Project Name | BCWD Permit 24-07, Elliott Crossing

Date | November 7, 2024

Regarding | Permit Application No. 24-07 Engineer's Report

Figure 4 - Irrigation Area (Pond 300)

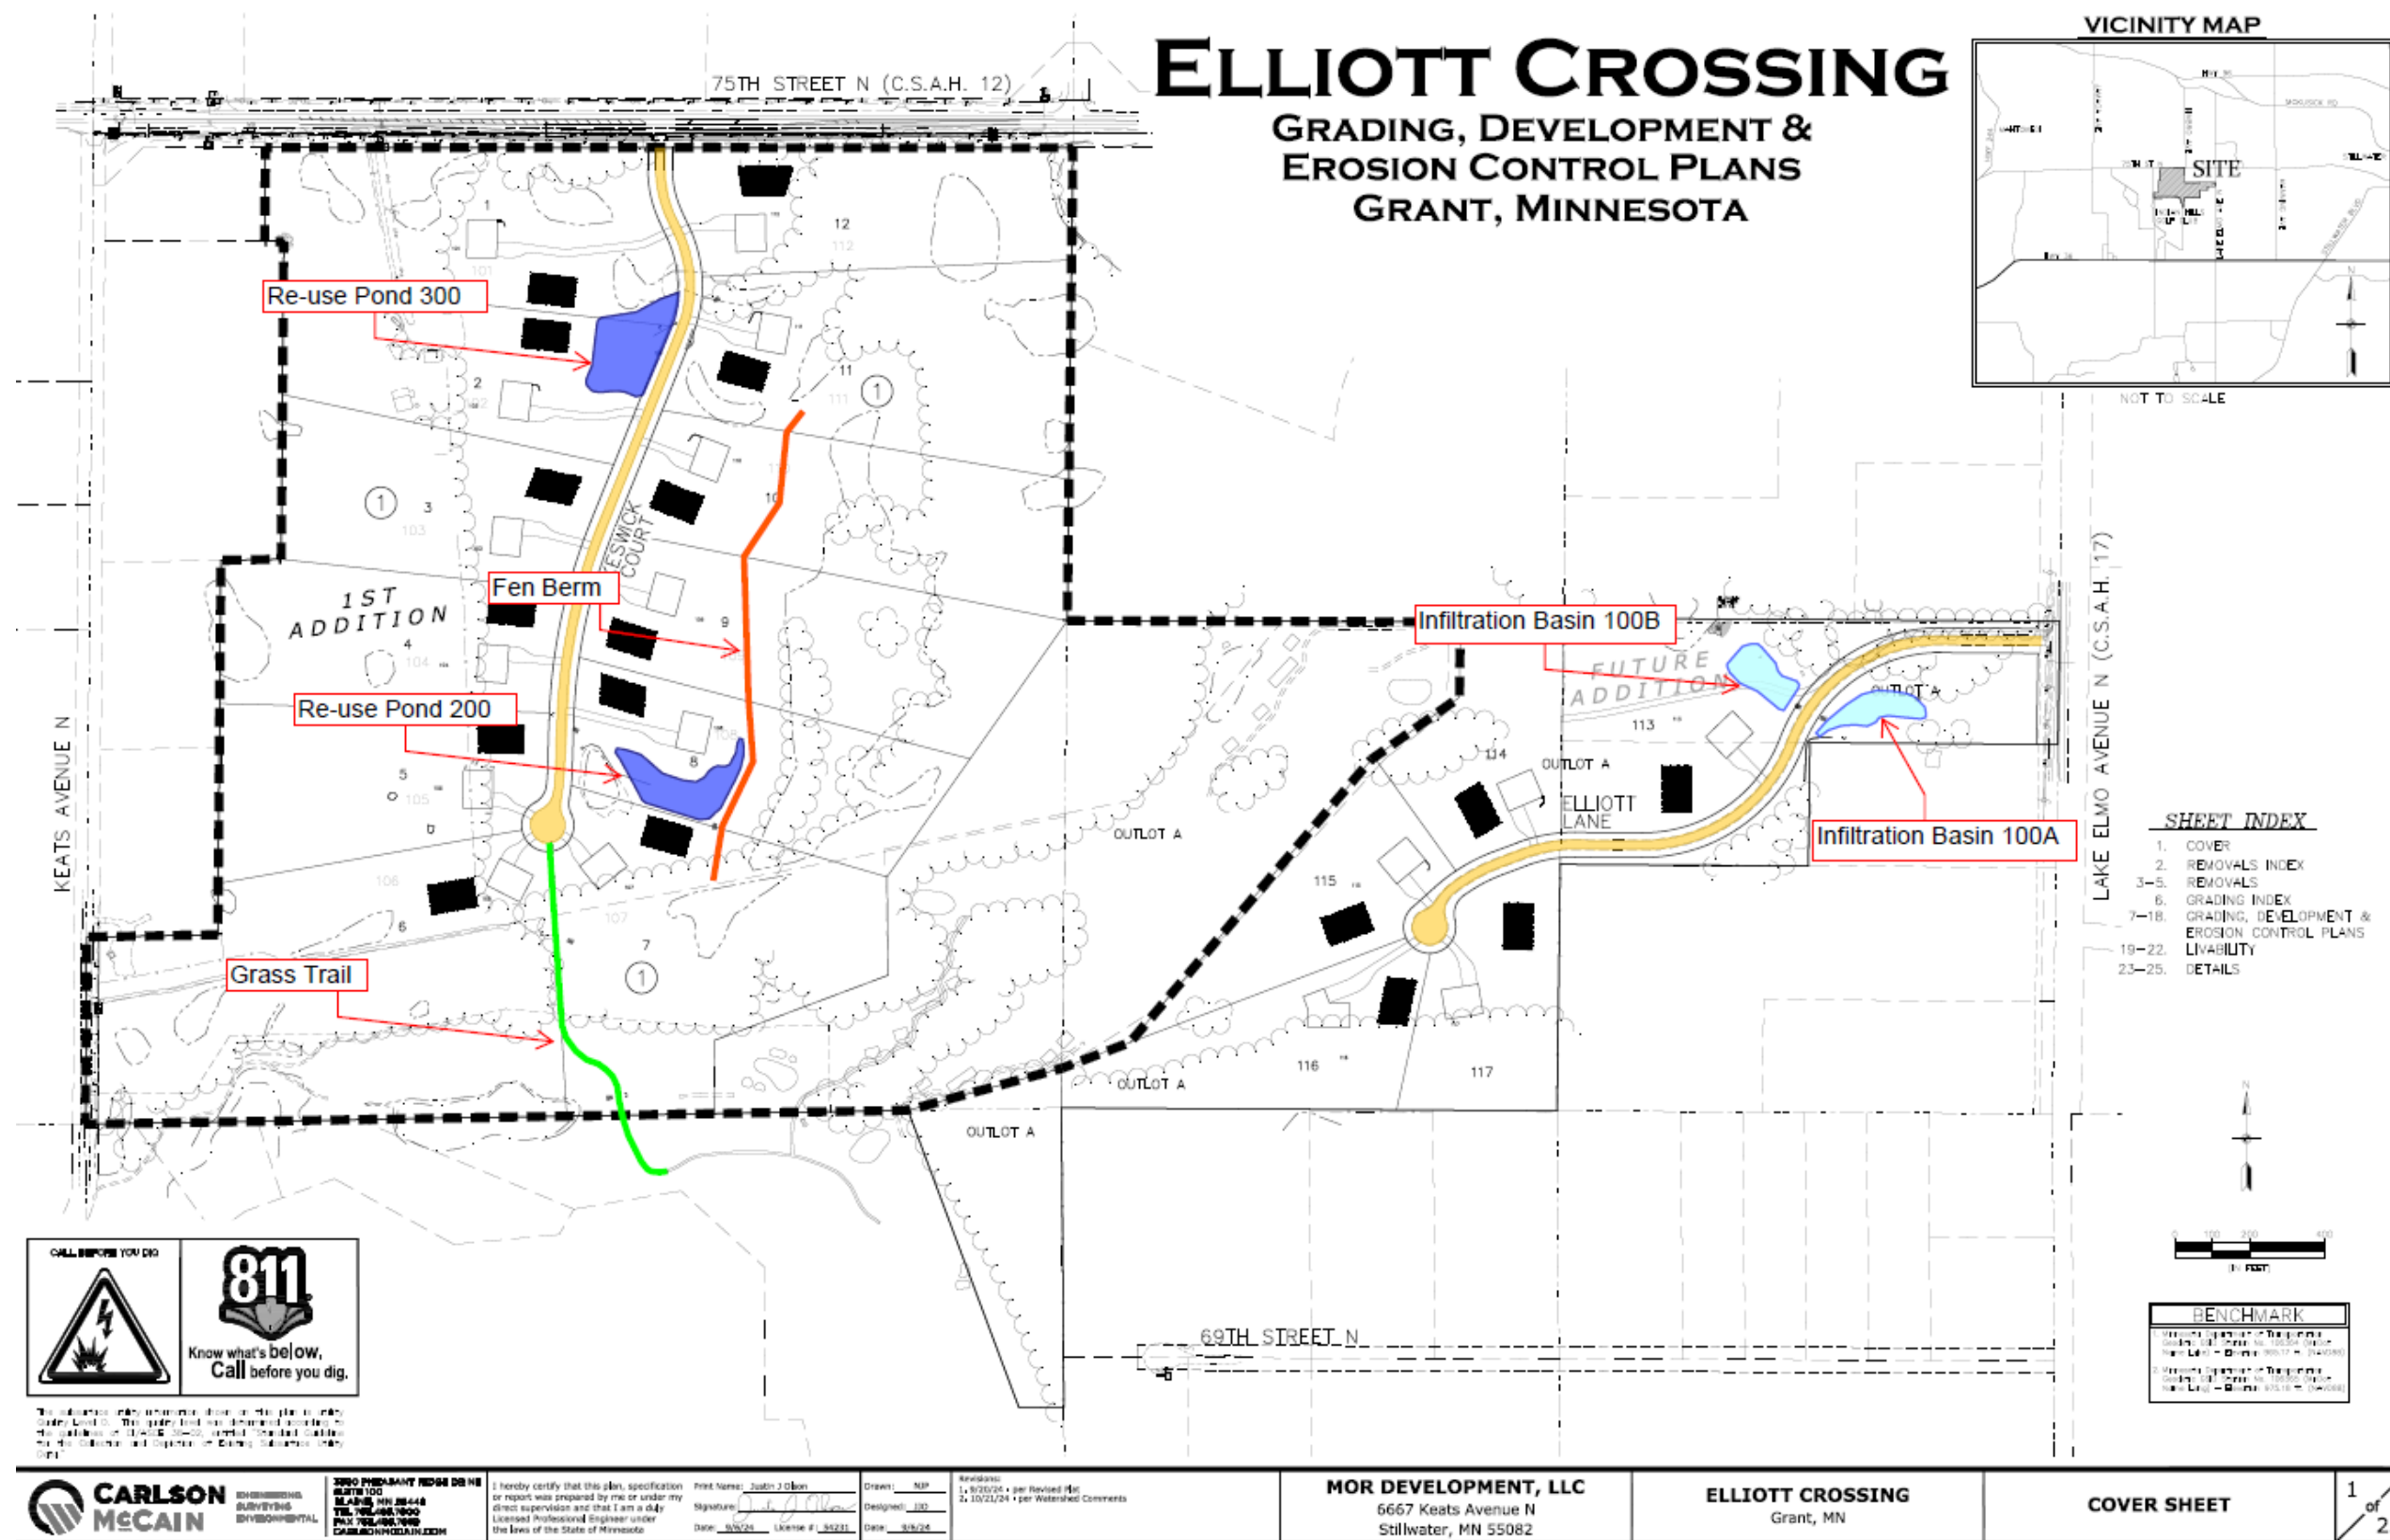
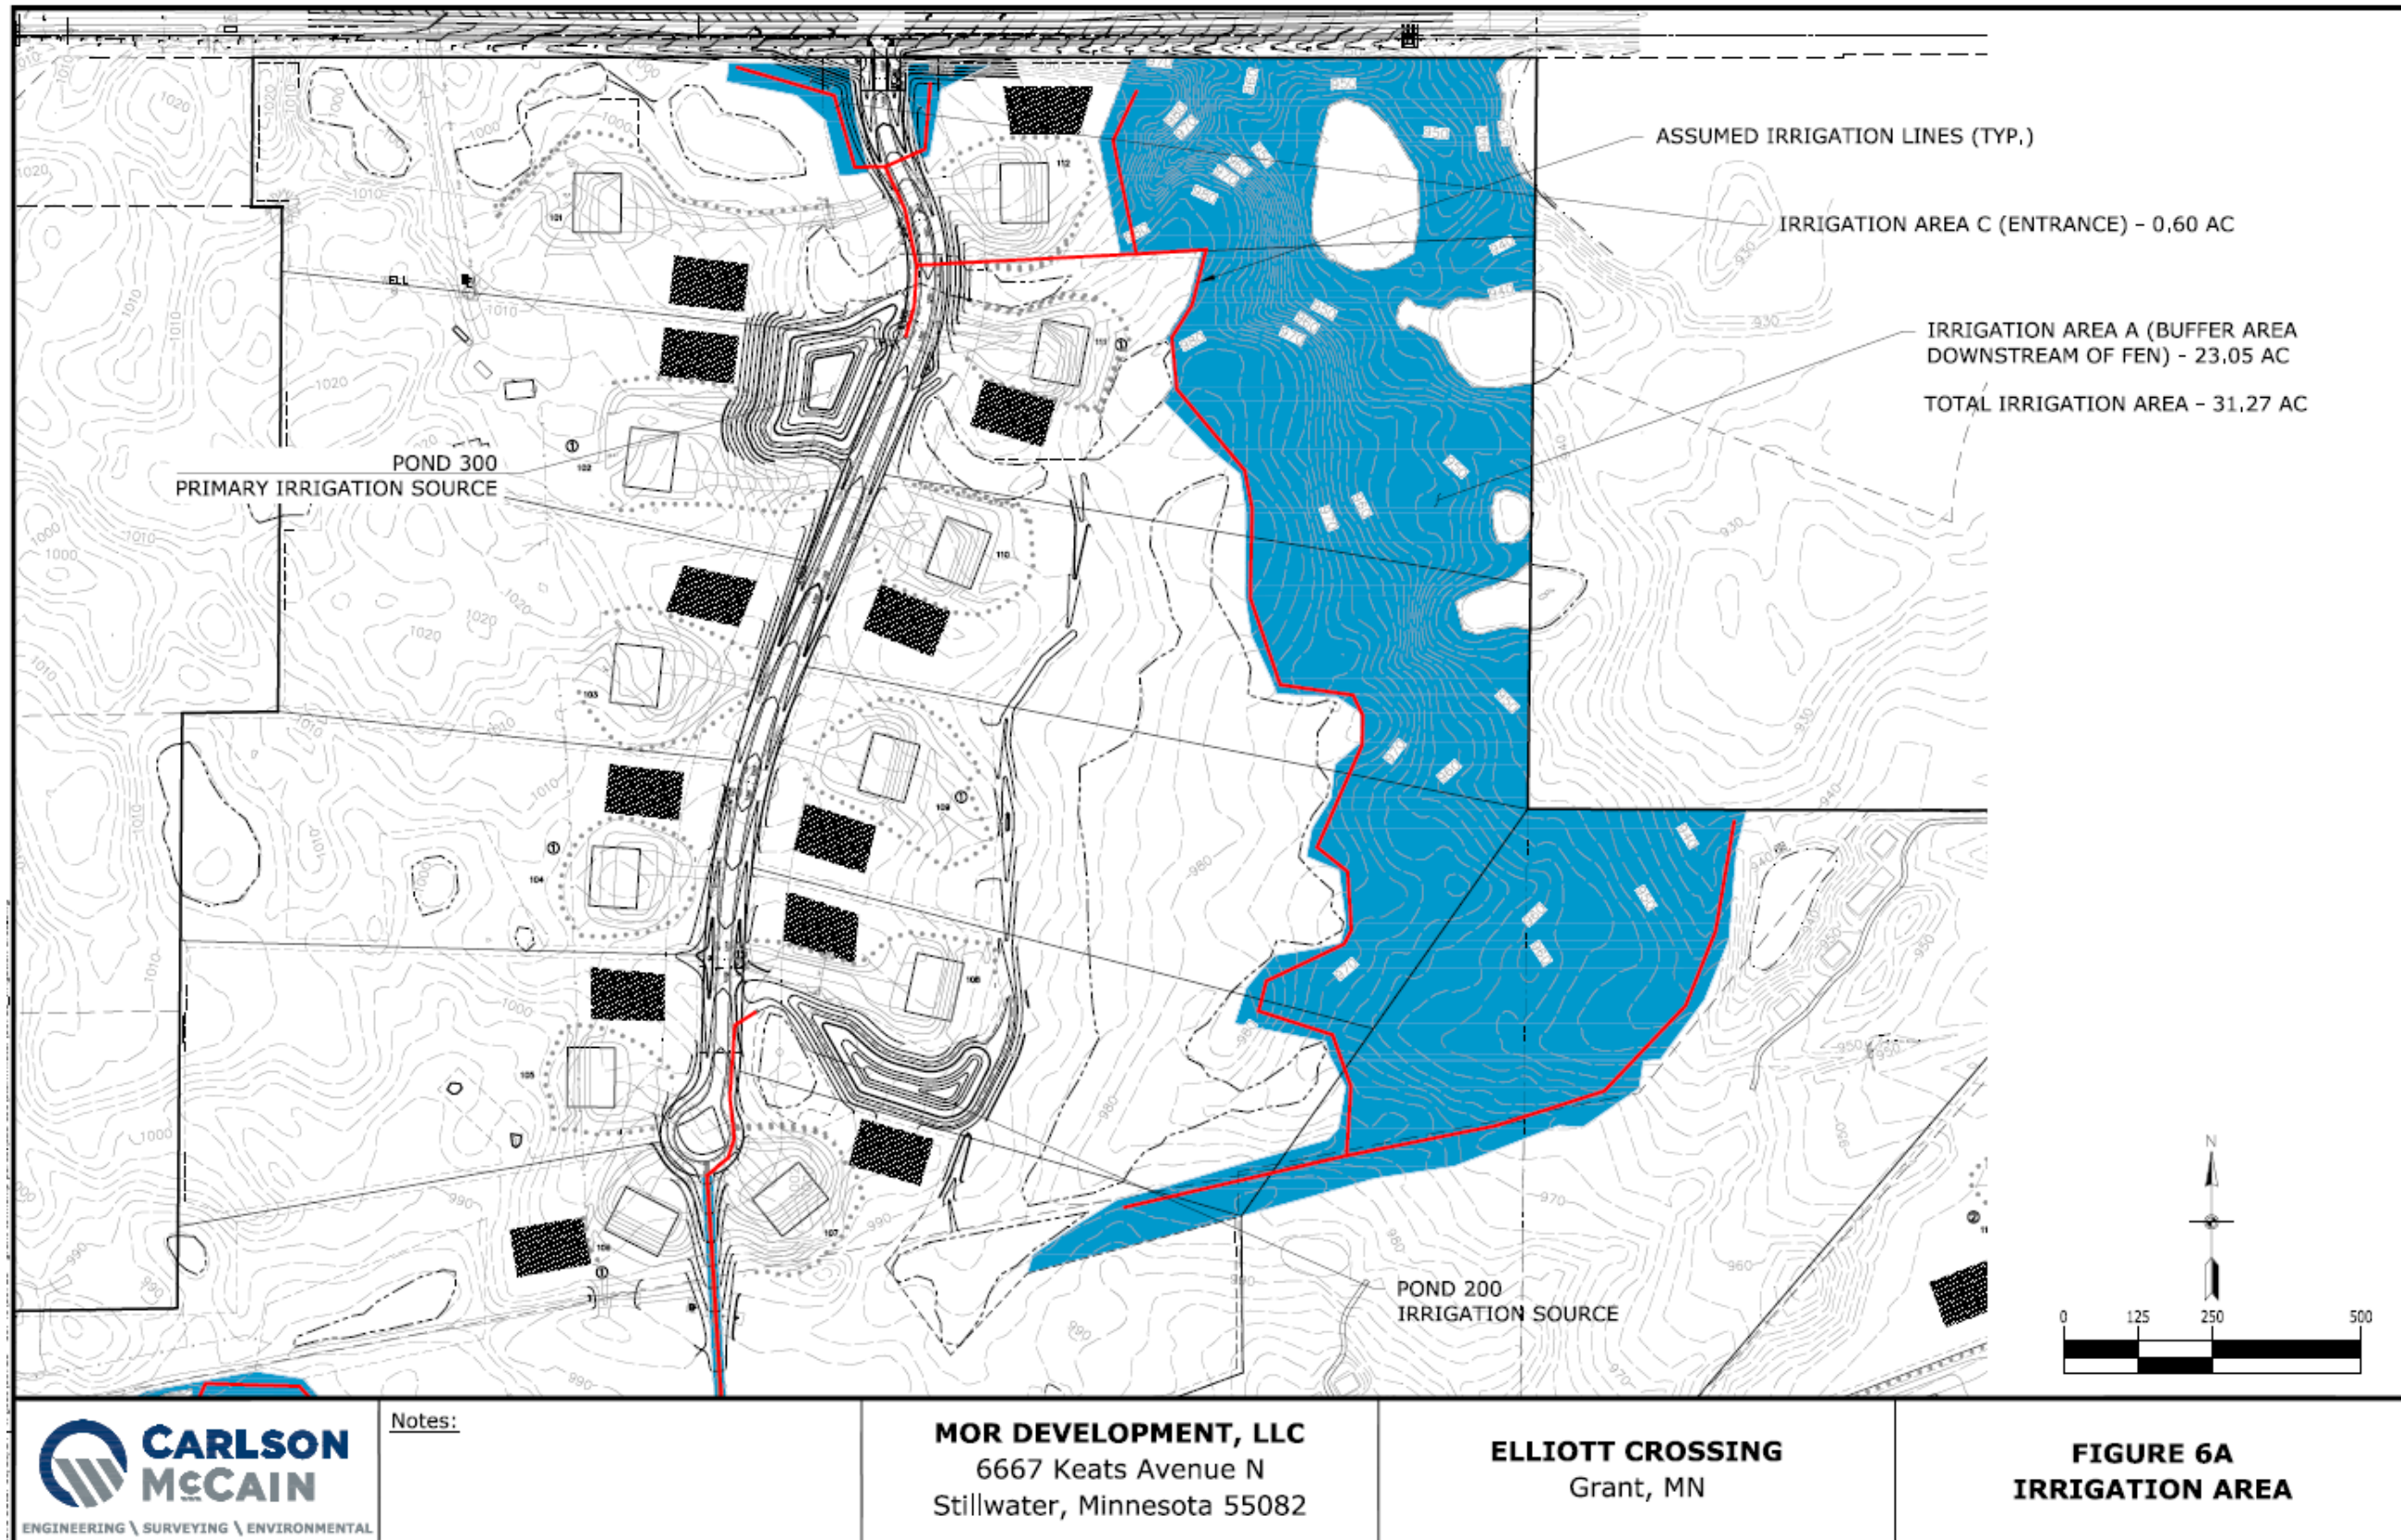
The two re-use ponds will provide stored stormwater to be used to irrigate a small, landscaped area at the site entrance along with the wetland buffers. Irrigation areas are shown in Figure 4 and Figure 5. Re-use Pond 300 will irrigate the buffer downstream (east) of the fen while Re-use Pond 200 will irrigate the buffers on the south side of the site around Wetlands M and N. The re-use ponds will be pumped down using an automated system. At an irrigation rate of 0.06 inches/hour (consistent with HSG D soils found in this portion of the site), both ponds can be drained within 48 hours to allow capacity for future storm events and for volume control analysis these ponds were assumed to start empty. The ponds are proposed to be drained at a lower rate to avoid saturation of the soil and runoff from irrigation. This would take longer than 48 hours to drain the ponds from full, depending on the pumping rate. This pumping rate is needed to confirm that the ponds will empty quickly enough to regain storage capacity between storms, such that the assumption of the ponds starting empty for volume control analysis is correct. Therefore, additional detail on the irrigation system is needed and will be required as a condition of permit approval. Specifically, the following must be provided:

- *Proposed pumping rate(s)*
- *Duration of time required to fully drain ponds*
- *Pond water levels that trigger pump operation*
- *Irrigation head velocity*

- 2-1. Provide BCWD with the final civil plan set (BCWD 2.7.9).
- 2-2. Provide the following information related to the stormwater irrigation system.
 - Proposed pumping rate(s)
 - Duration of time required to fully drain ponds

- Pond water levels that trigger pump operation
 - Irrigation head velocity
- 2-3. Provide a draft stormwater facility maintenance declaration for BCWD approval, then, after approval, provide proof of recordation with Washington County (BCWD 2.6). A template is available under the permit section of the District's website. The maintenance declaration must include the following:
- Protection of all vegetated areas that must be preserved for irrigation use on the property, and
 - Annual documentation of the volume of water used for irrigation along with the dates during which the irrigation system was active.
- 2-4. Provide documentation as to the status of a National Pollutant Discharge Elimination System stormwater permit for the project from the Minnesota Pollution Control Agency and provide the storm water pollution prevention plan (BCWD 2.7.15).
